**SUBJECT: RFP NO. 071755 ADMINISTRATION BUILDING ELECTRIC VEHICLE
CHARGING STATIONS**

**Response to Bid
Questions #04**

1 DISTRIBUTION DETAIL
SCALE: 3/8"=1'-0"

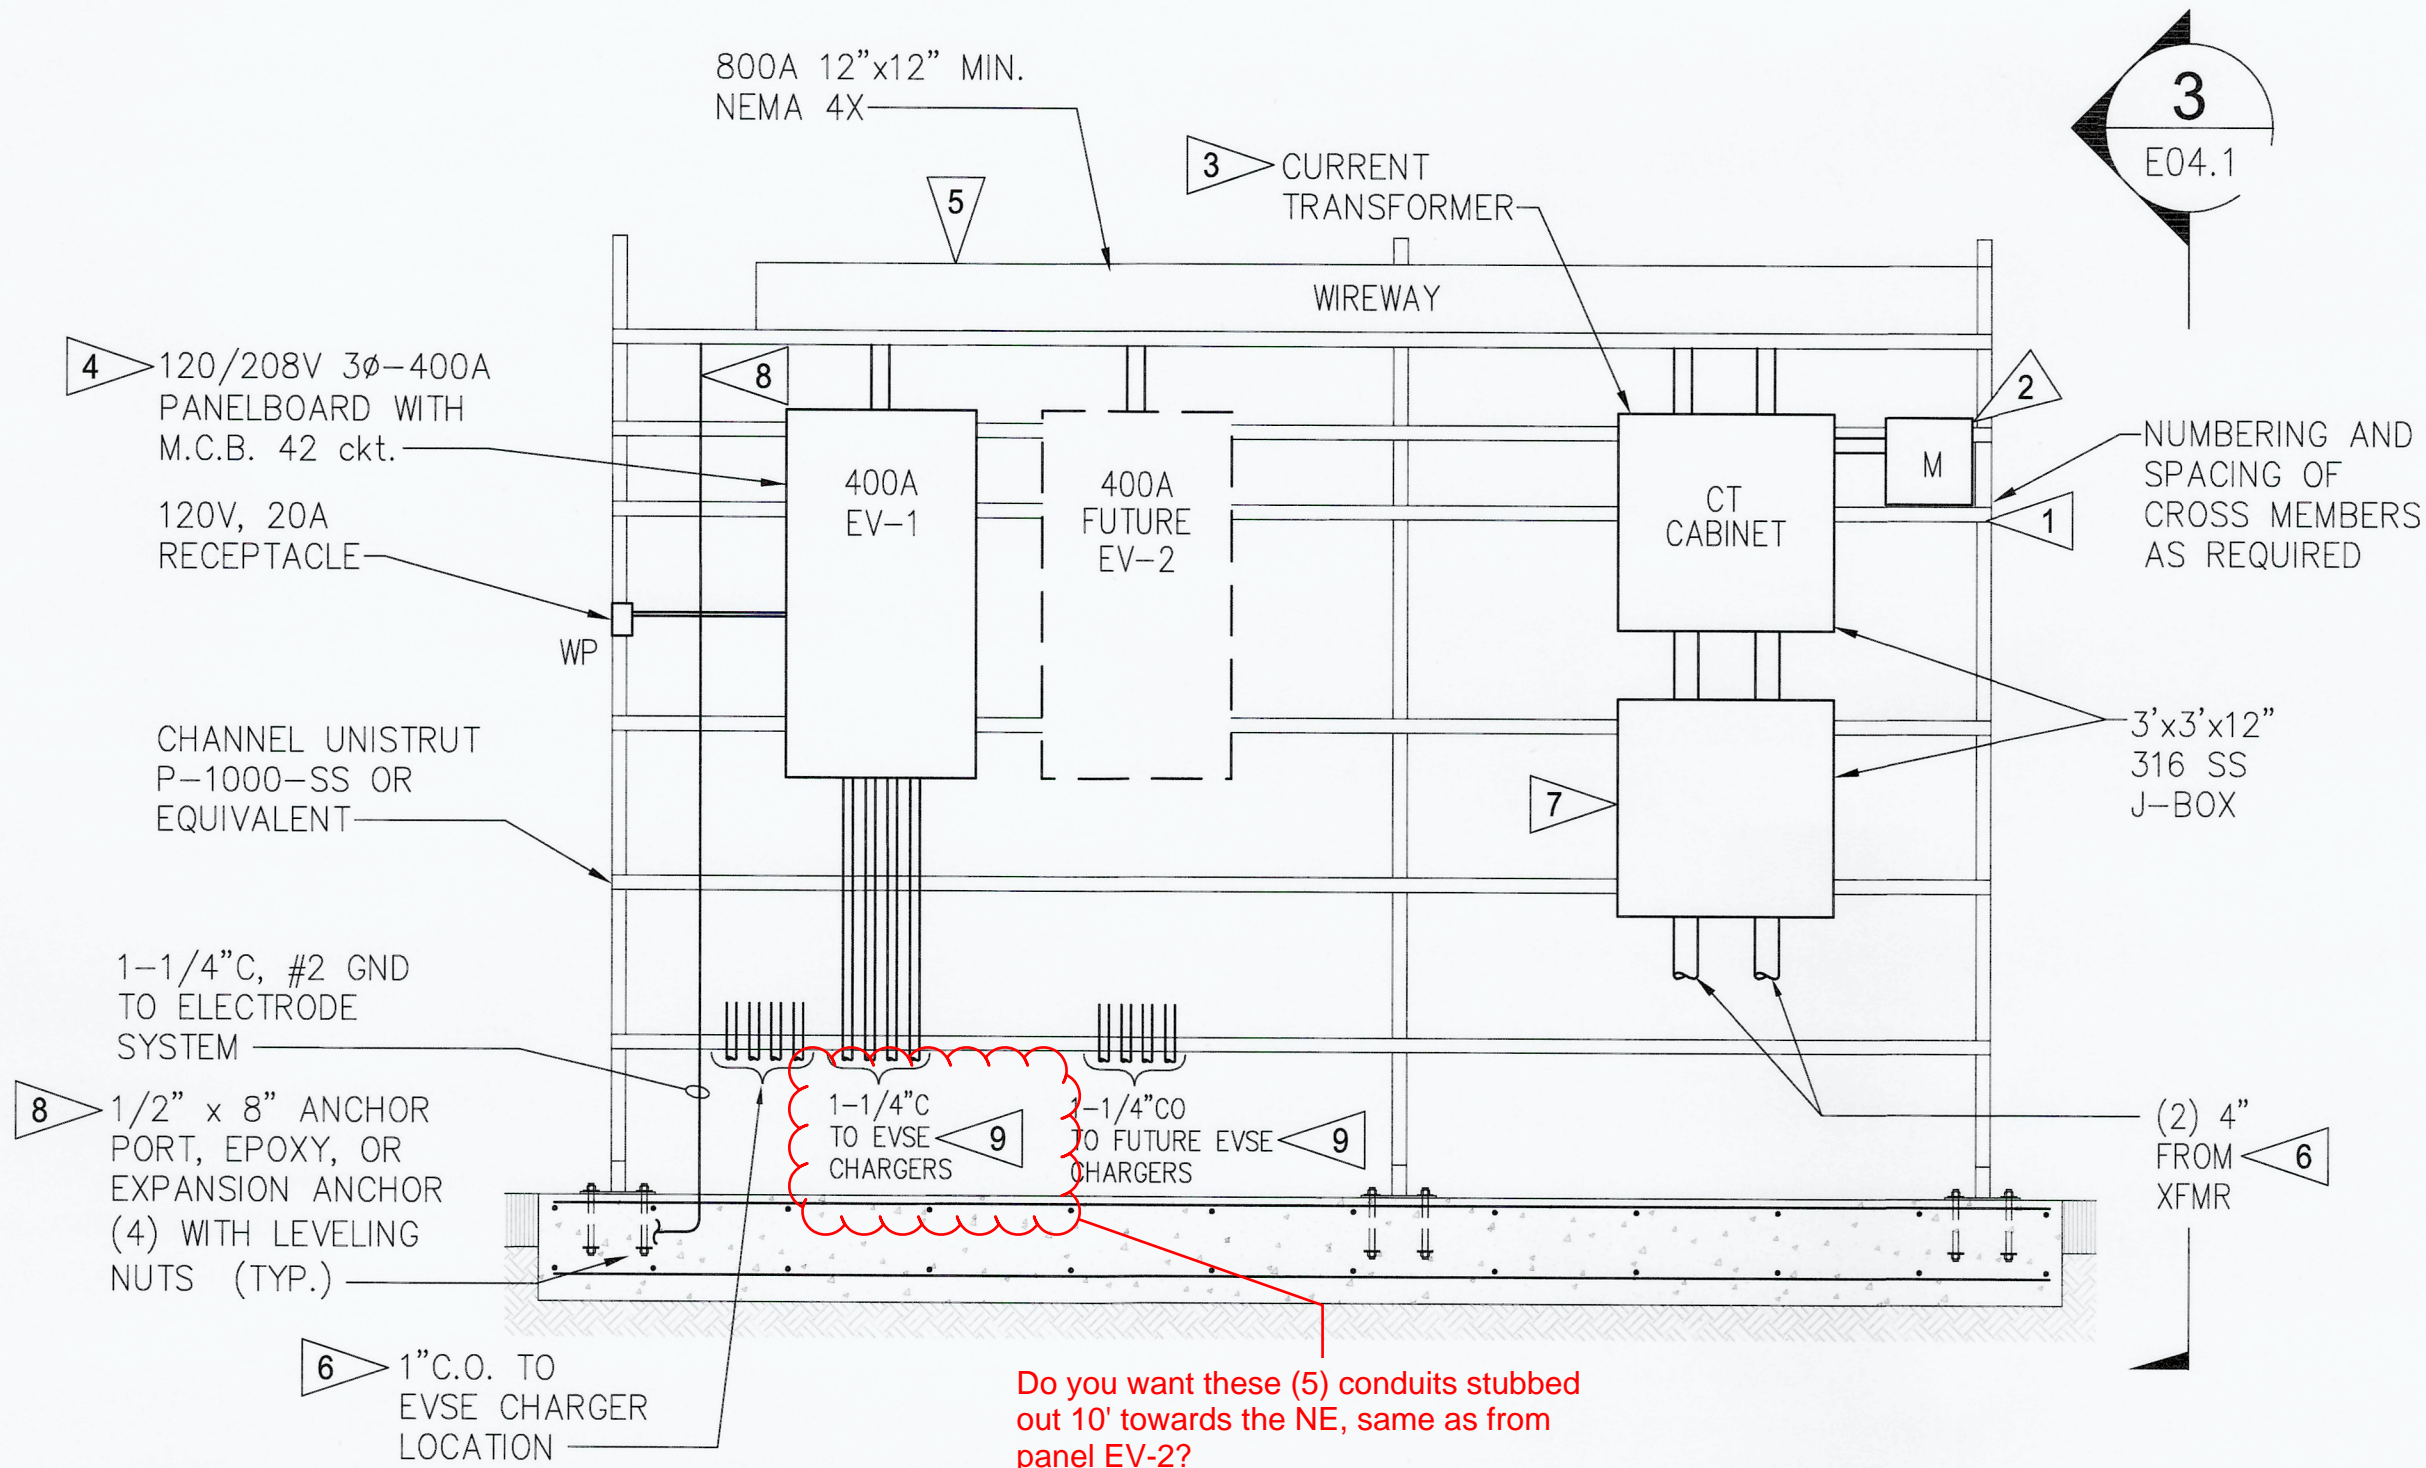
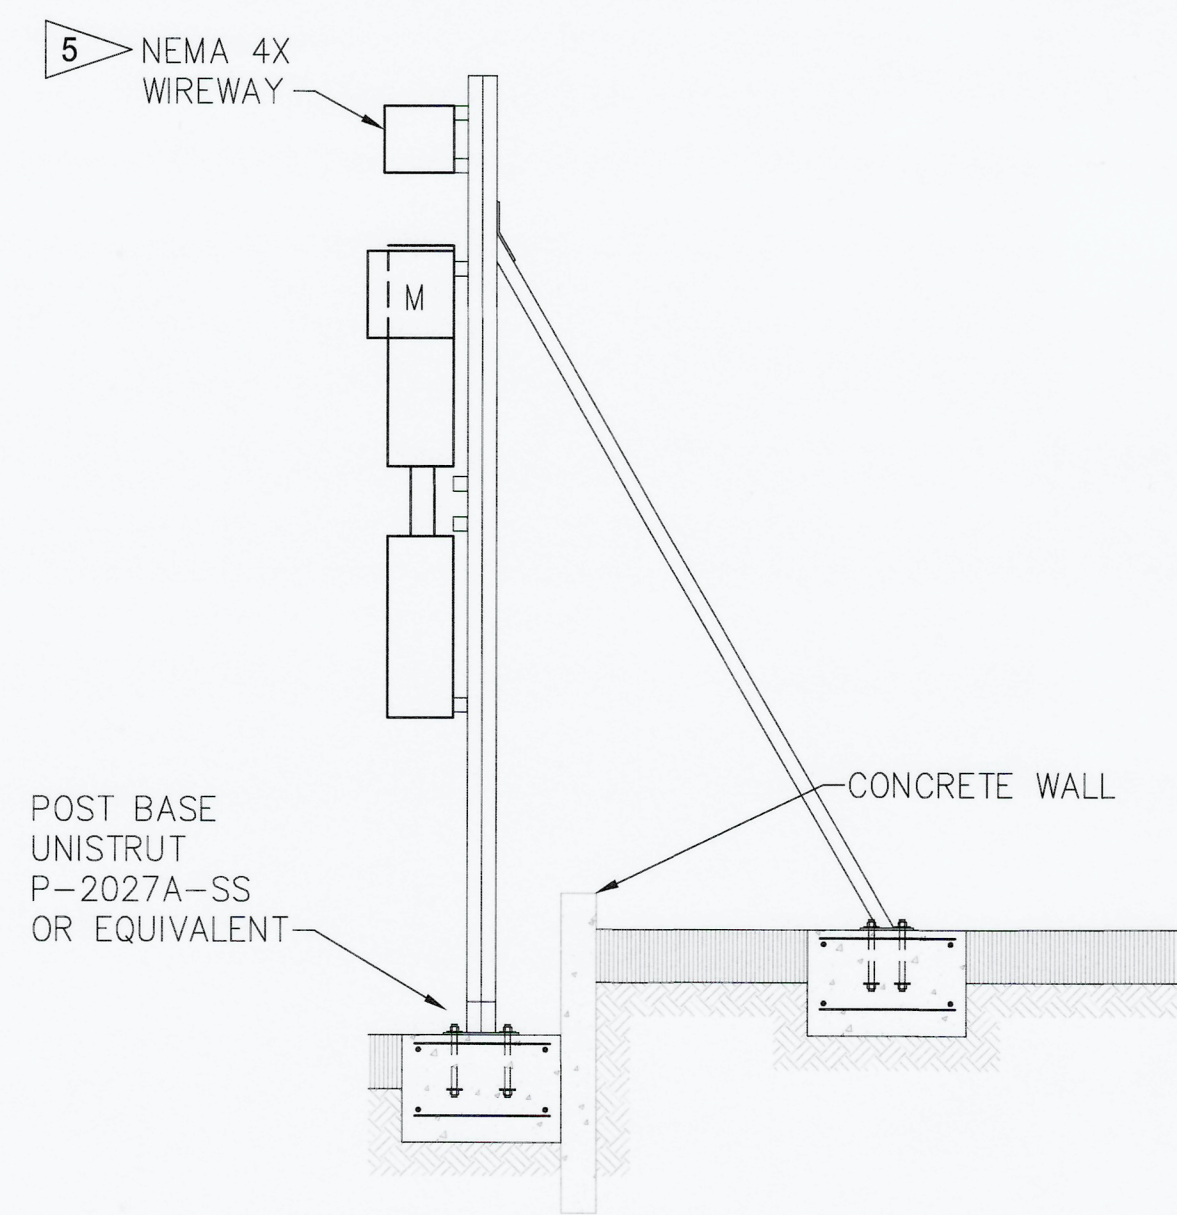
4. Questions from E04.1, Distribution Service Detail drawing. (See attachment for location of questions on the drawing)

Flag note 6 indicates conduit and wire but, there is no information on what wire is needed for communications.

Do you want these (5) conduits stubbed out 10' towards the NE, same as from panel EV-2?

Where conduit only (C.O.) is identified on drawings for power or communications conduits, NO wire is required for those conduits. See bubbled revision A1 drawing E04.1 in addendum 1.

No, these power conduits are to base bid EVSE charger locations. Note flag 9 is to be flag note 6. (5) power conduits (C.O.) only from EV-2 and (5) communications conduits only (C.O.) from localized Communication location on back side of the equipment rack shall be stubbed 10 feet out to the NE for future EVSE charger locations. See bubbled revision A1 drawing E04.1 in addendum 1.

1. (5) 1 "communications conduits (C.O.) are required along with the power conduit to the future EVSE charger. Provide power and communications C.O. to NE location as described on Sheet E04.1 See bubbled A1 revision and flag note 9 drawing E04.1 in addendum 1.
2. Ground electrode conduit and conductor did not terminate in Wireway (Gutter). This was corrected on the drawing with notes to clearly identify requirements for ground electrode routing on the drawing. See bubbled A1 revision and flag note 8 drawing E04.1 in addendum 1.

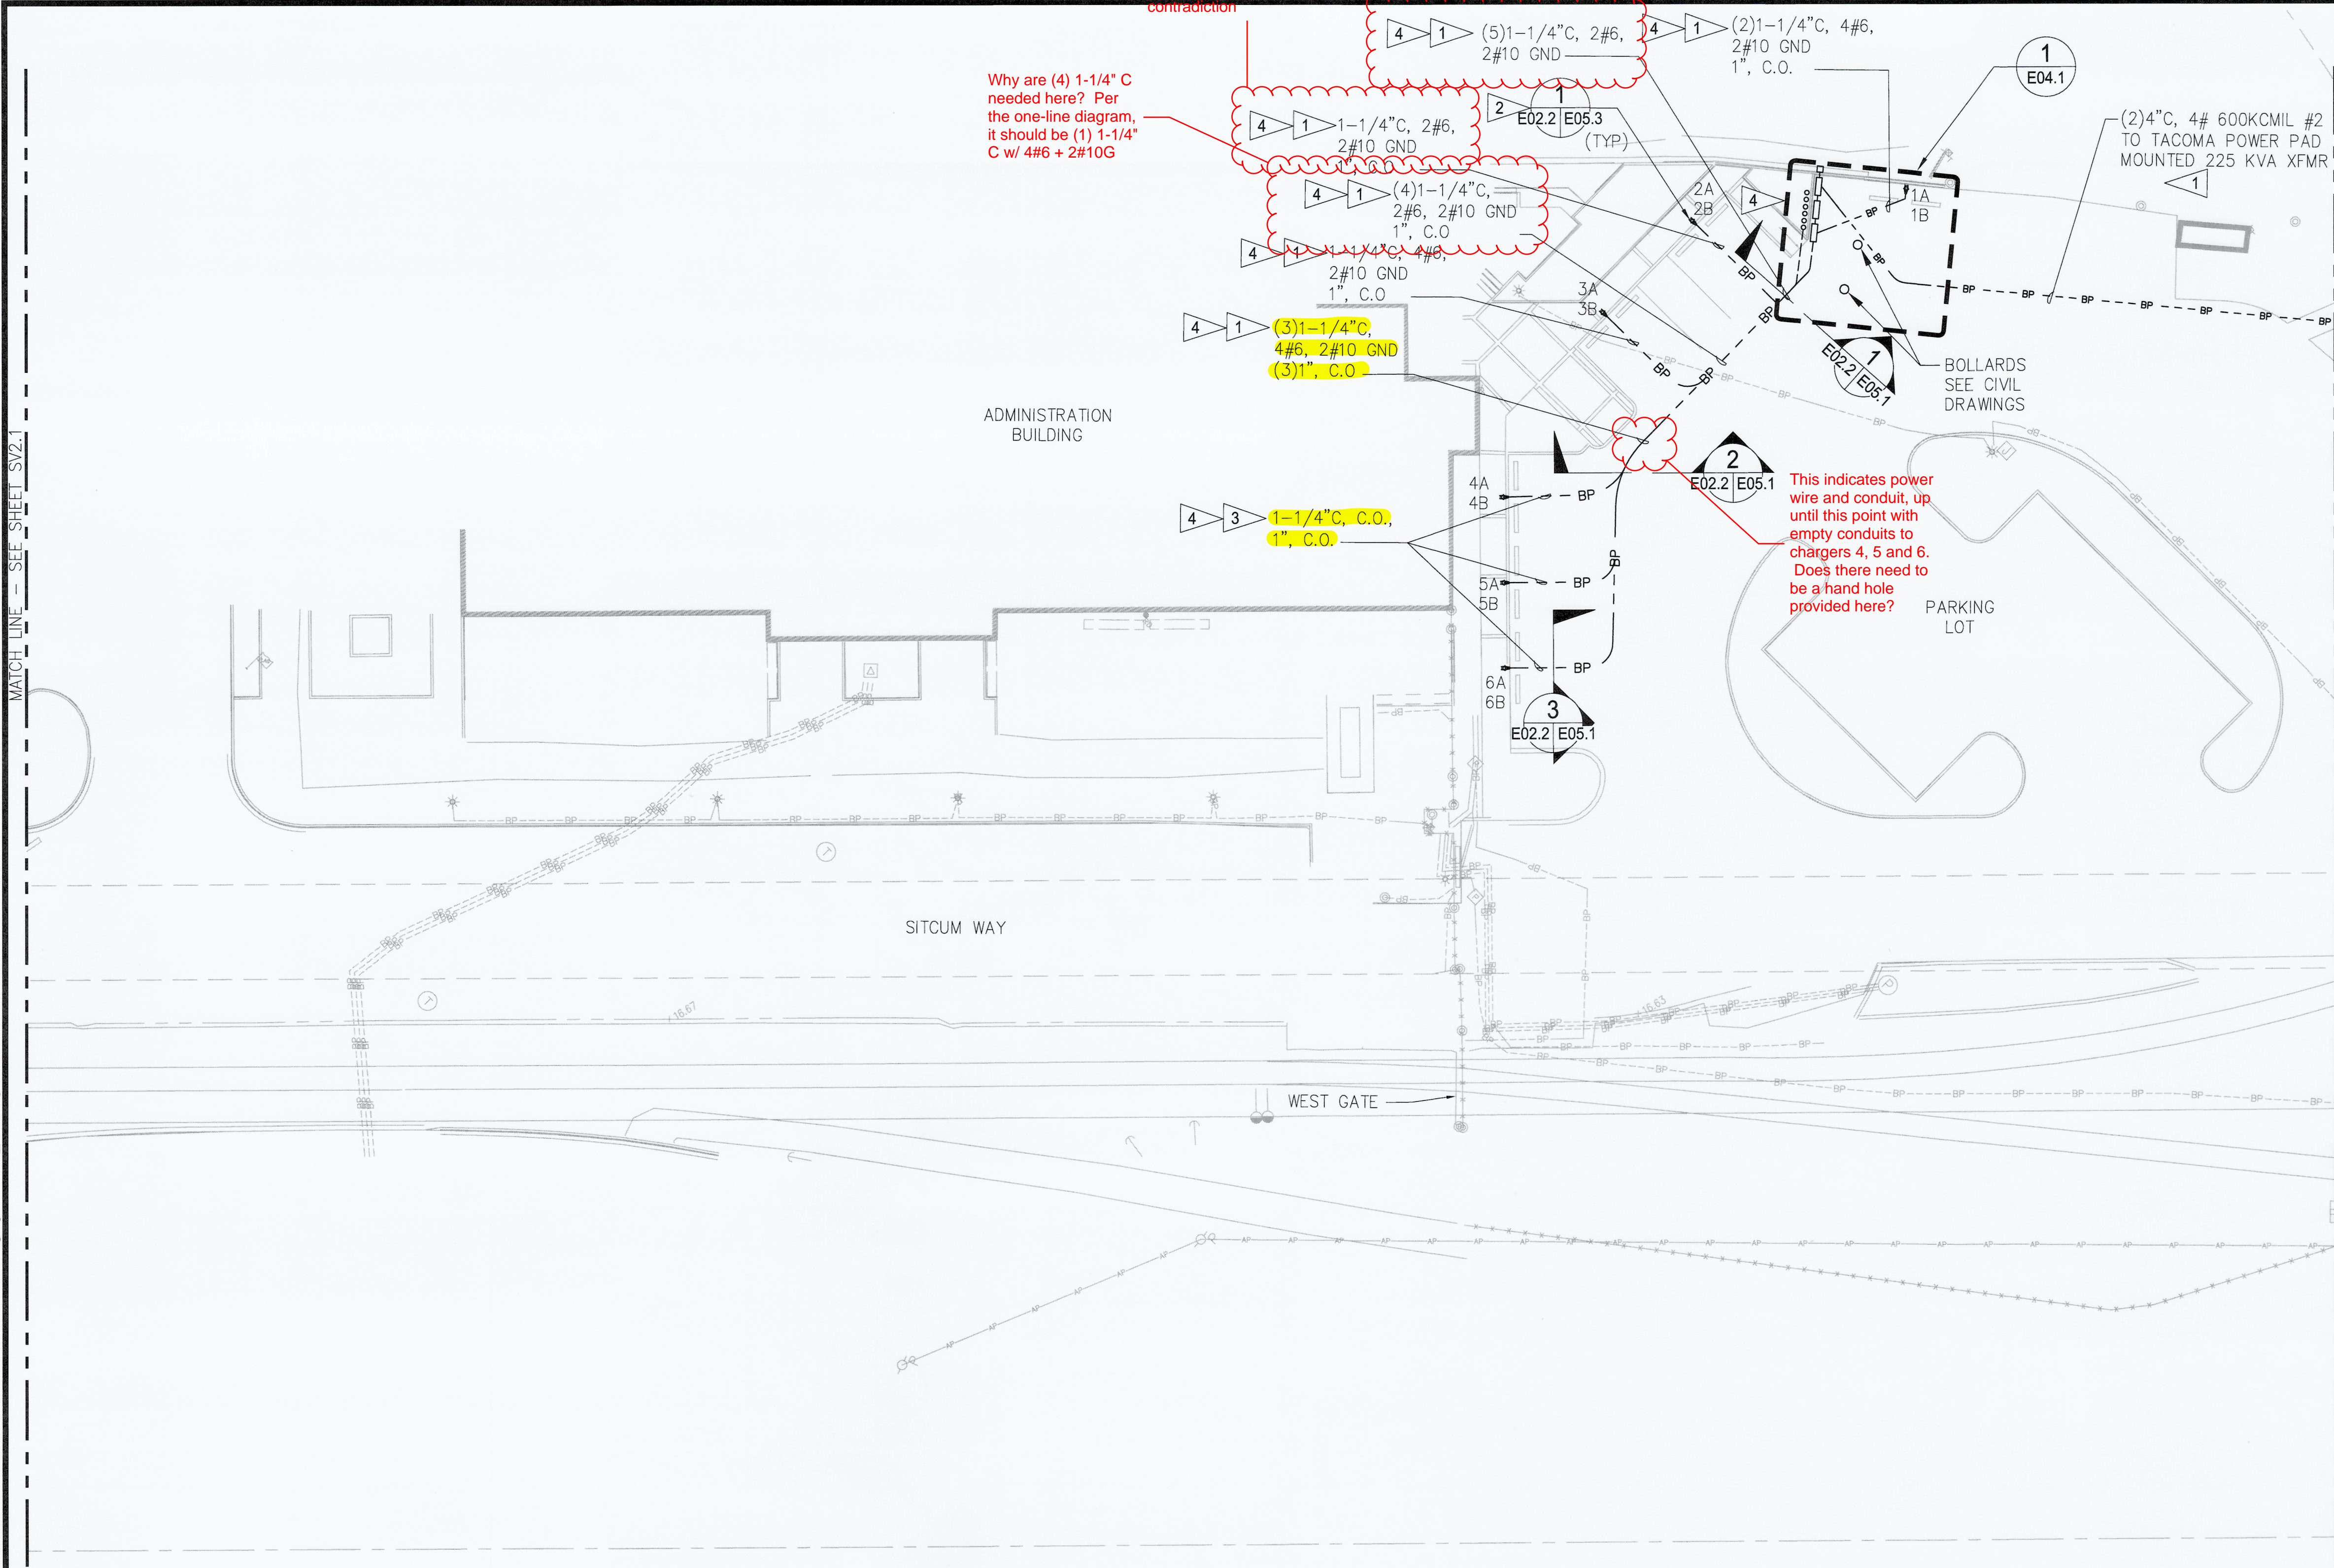
3. Questions from E02.2, Site Plan (1) drawing. (See attachment for location of questions on the drawing)

The one-line diagram indicates 4#6 + 2#2G and what's listed here is in direct contradiction.

Why are (4) 1-1/4" C needed here? Per the one-line diagram, it should be (1) 1-1/4" C w/ 4#6 + 2#10G.

This indicates power wire and conduit, up until this point with empty conduits to chargers 4, 5 and 6. Does there need to be a hand hole provided here?

The one-line diagram indicates 4#6 + 2#10G. One line diagram is correct wire count. Plan view conduit wire count has been adjusted to match one line diagram. See bubbled revision A1 drawing E02.2 in Addendum 1.

(4) 1-1/4" Power conduits are required at this point. (3) 1-1/4" power conduits shall be conduit only (C. O.) and one will be filled, (1) filled 1-1/4" C w/ 4#6 + 2#10G. Plan view

conduit and wire count has been adjusted to match one line diagram. See bubbled revision A1 drawing E02.2 in Addendum 1.

Conduit only is required for base bid from panel EV -1 to bid alternate EVSE locations. Conduit fill wire will be required only if bid alternate EVSE locations are accepted for work. NO wire transition will be required at this point.

Plan view conduit and wire count has been adjusted to match one line diagram. See bubbled revision A1 drawing E02.2 in Addendum 1.
